Charlotte-Mecklenburg Planning, Design, & Development

SUBJECT: Administrative Approval for Petition No. 2020-035 CCP University, LLC

ADMINISTRATIVE AMENDMENT # RZAAMA-2021-00044

CHARLOTTE, NC REZONING #2020-035

• The site plan complies with the conditional notes and still meets the intent of the original approval by the City Council.

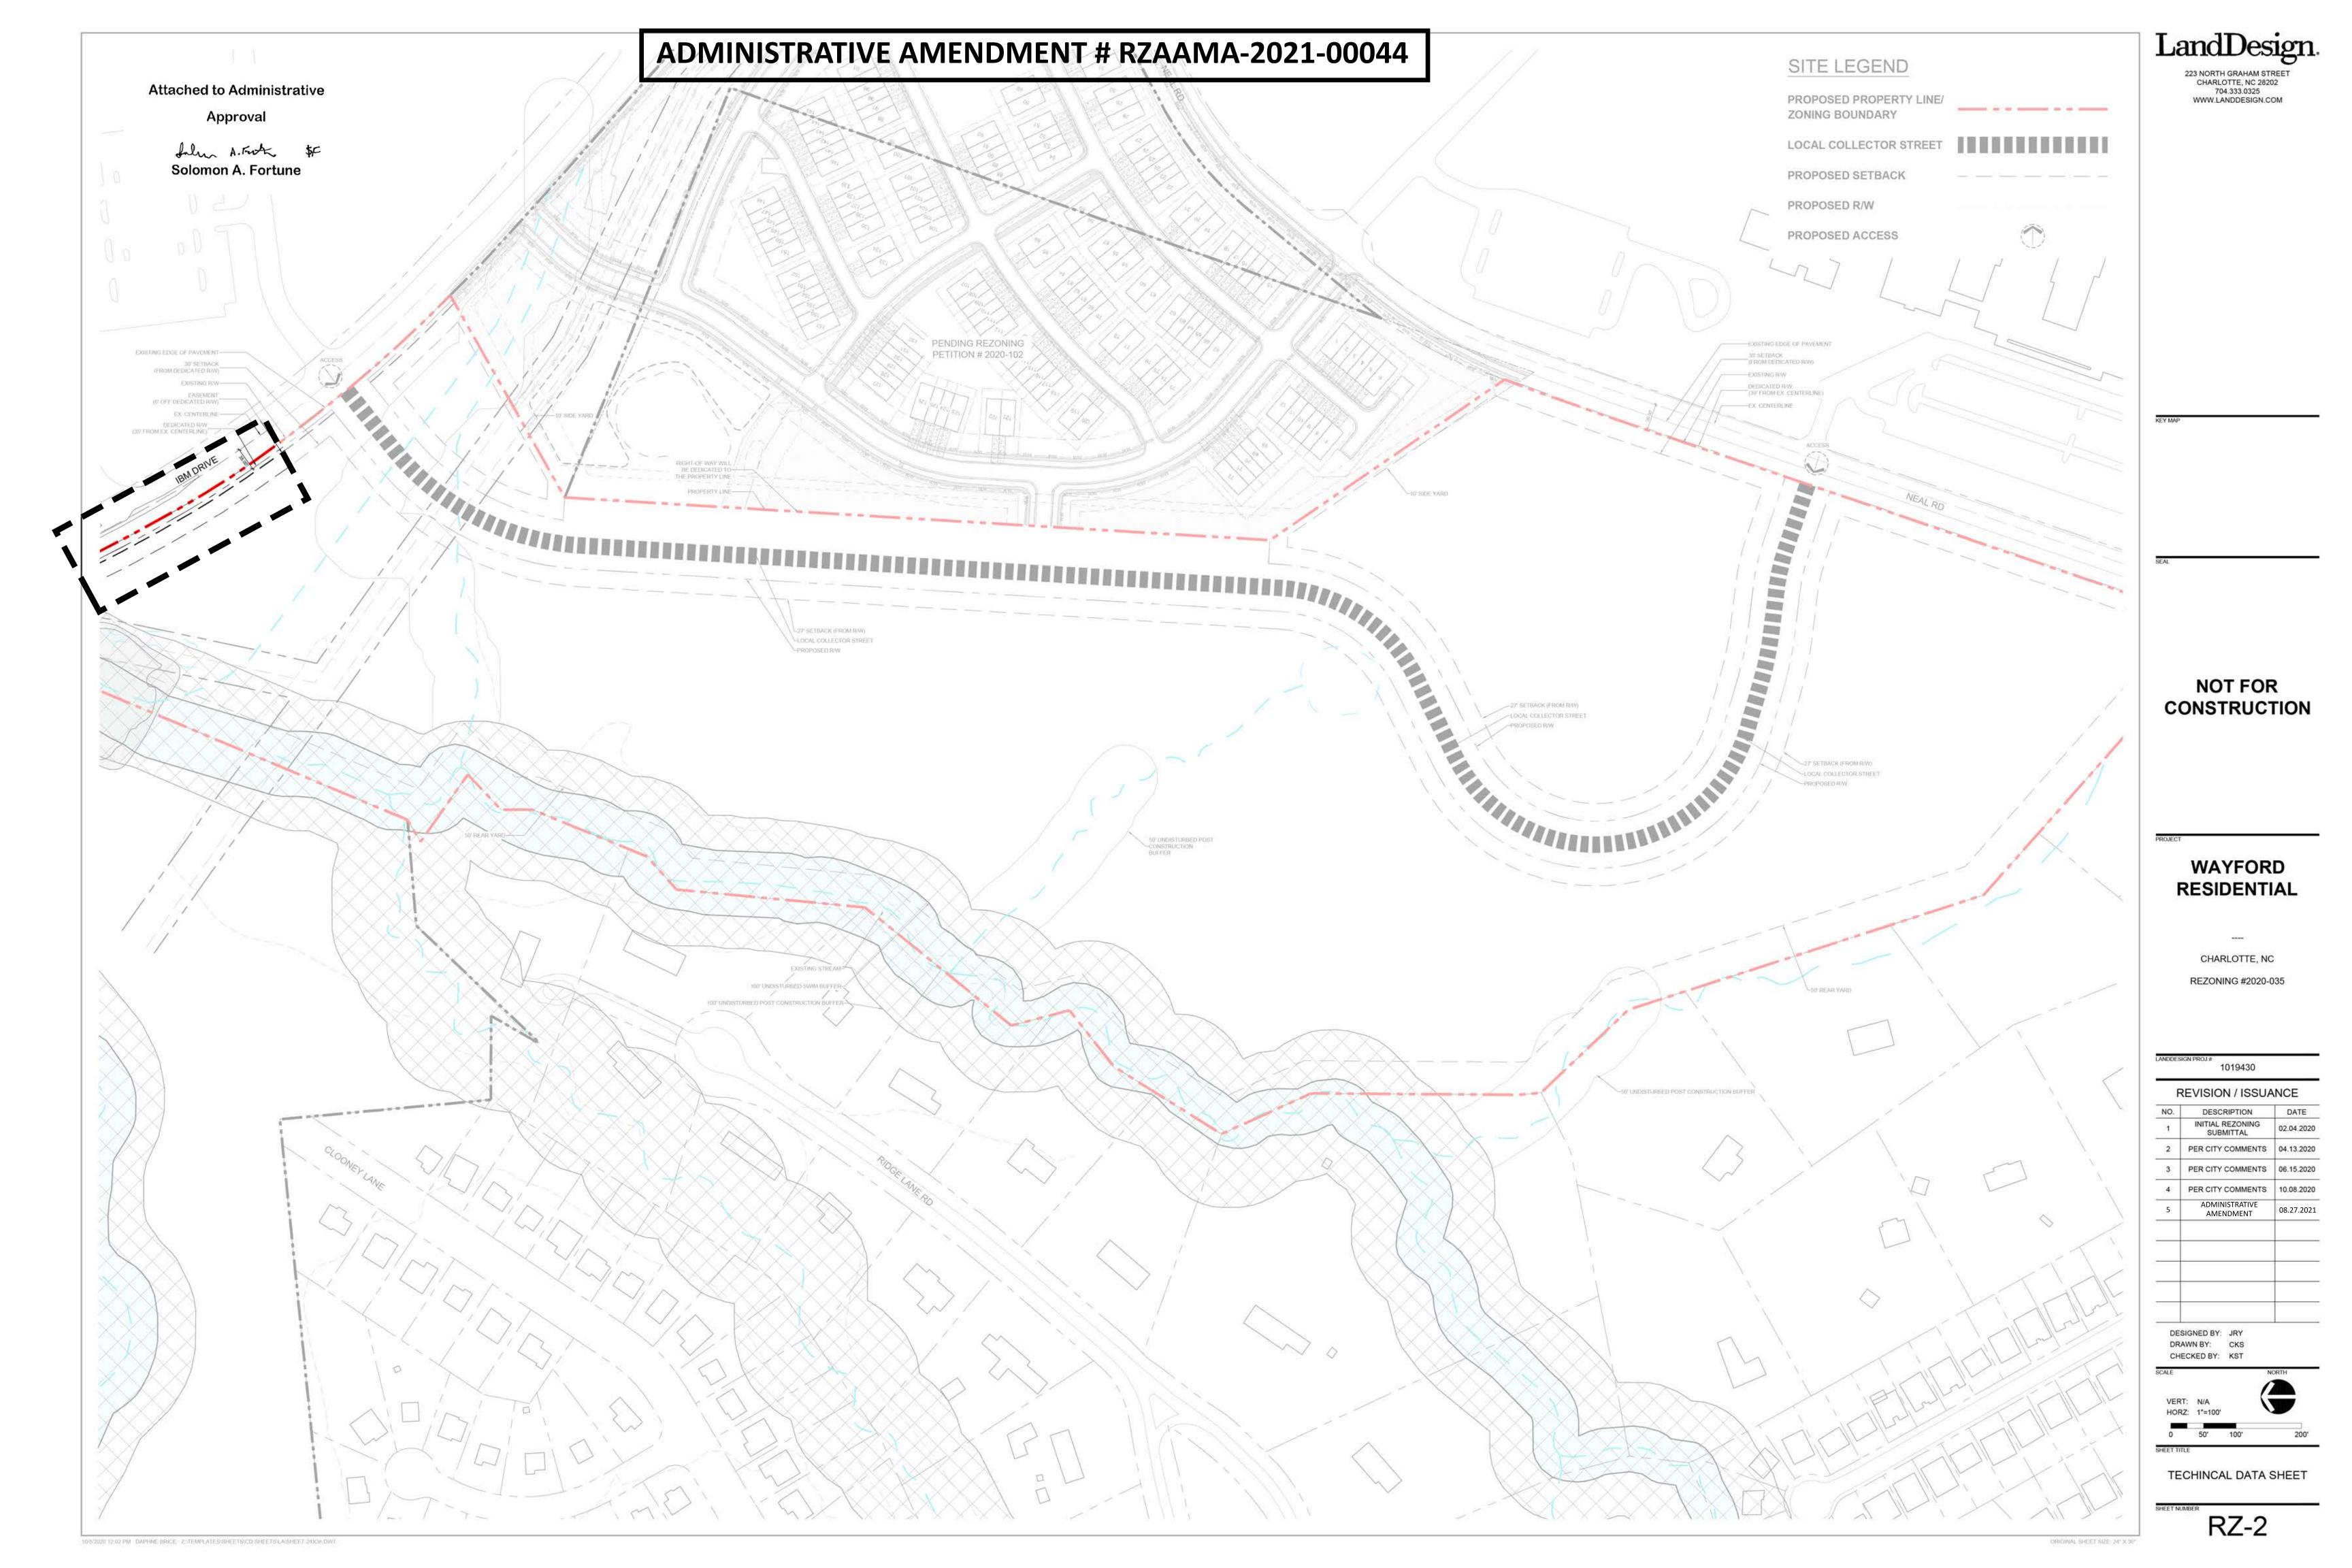
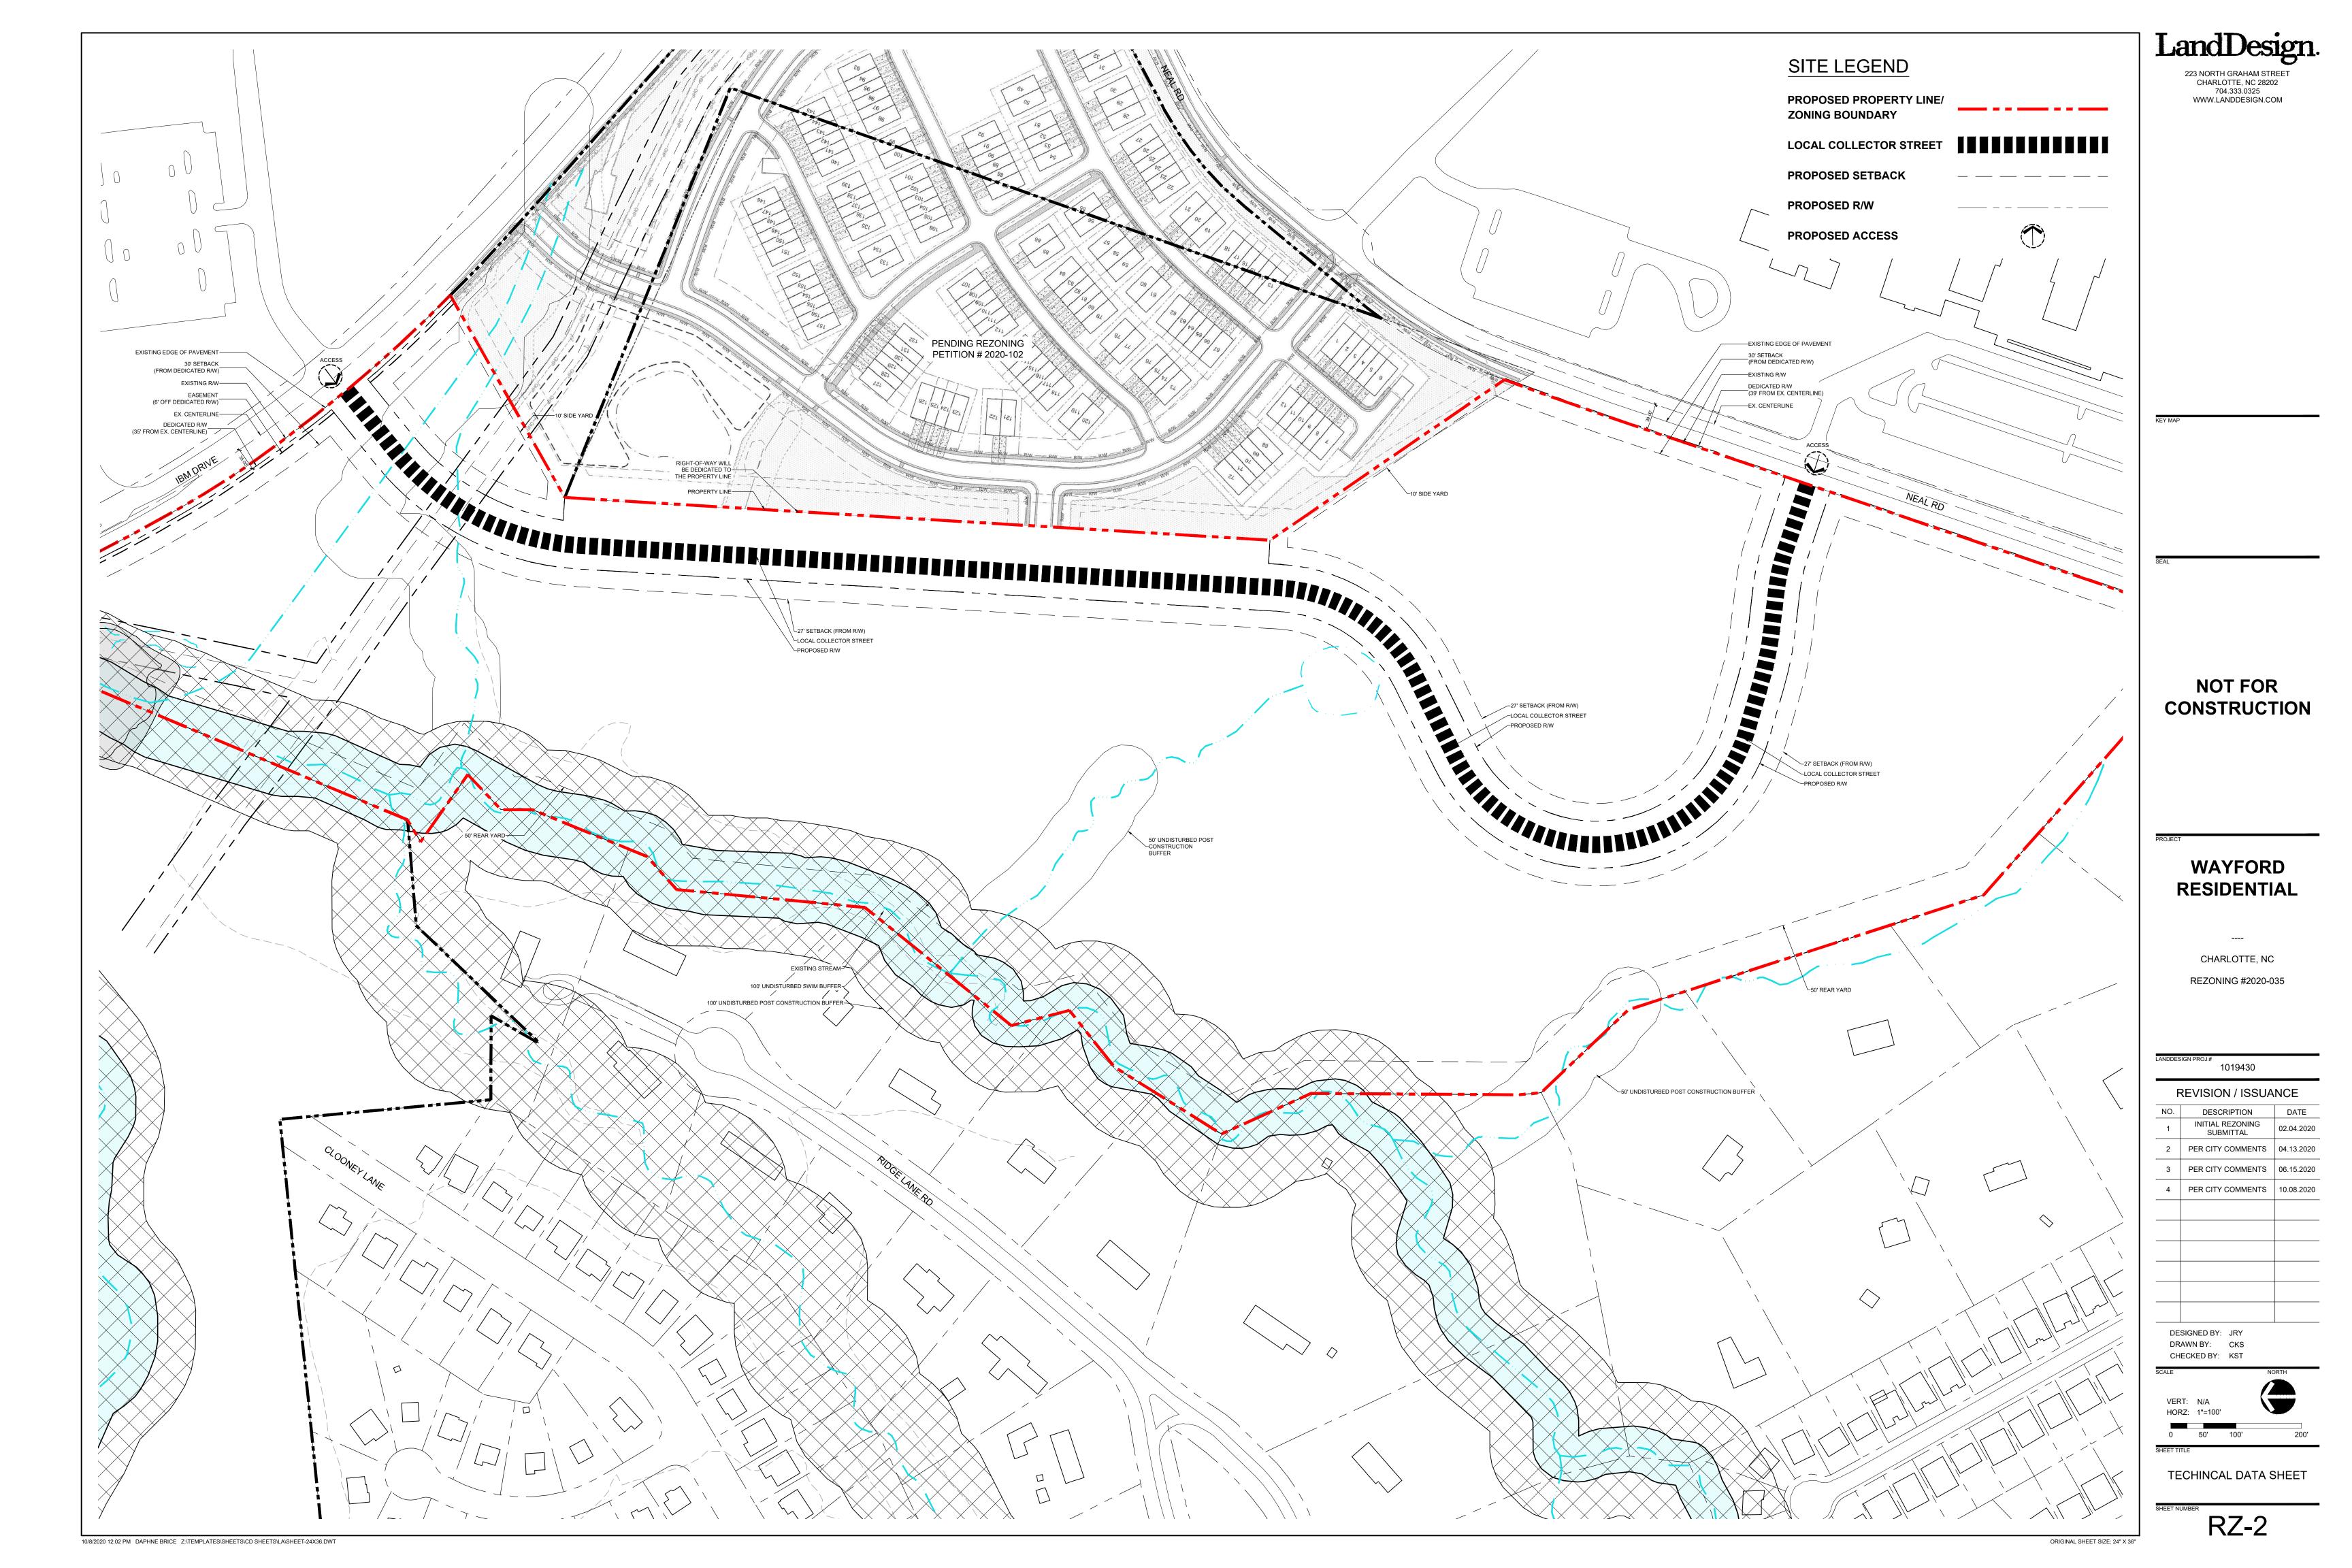
• Modification to the proposed streetscape and sidewalk along a portion of IBM Drive.

. THE PETITIONER SHALL CONSTRUCT A MINIMUM SIX (6) FOOT SIDEWALK AND EIGHT (8) FOOT WIDE PLANTING STRIP ALONG THE SITE'S INTERNAL PUBLIC STREETS. THE PETITIONER SHALL CONSTRUCT A MINIMUM SIX (6) FOOT SIDEWALK AND EIGHT (8) FOOT WIDE PLANTING STRIP ALONG THE SITE'S FRONTAGE WITH IBM DRIVE EXCEPT WHERE SITE CONDITIONS, INCLUDING DRAINAGE AND TOPOGRAPHY, DO NOT PERMIT AS INDICATED IN THE ADMINISTRATIVE AMENDMENT. WHERE THESE CONDITIONS EXIST, THE PETITIONER MAY CONSTRUCT A SIX (6) FOOT WIDE SIDEWALK AT THE BACK OF CURB ON THE SITE'S FRONTAGE WITH IBM DRIVE, AS GENERALLY DEPICTED IN THE ADMINISTRATIVE AMENDMENT. THE PETITIONER SHALL PROVIDE A MINIMUM TWELVE (12) FOOT WIDE SIDEWALK AND EIGHT (8) FOOT WIDE PLANTING STRIP ALONG THE SITE'S FRONTAGE OF NEAL ROAD, PER SECTION III.5. ABOVE.
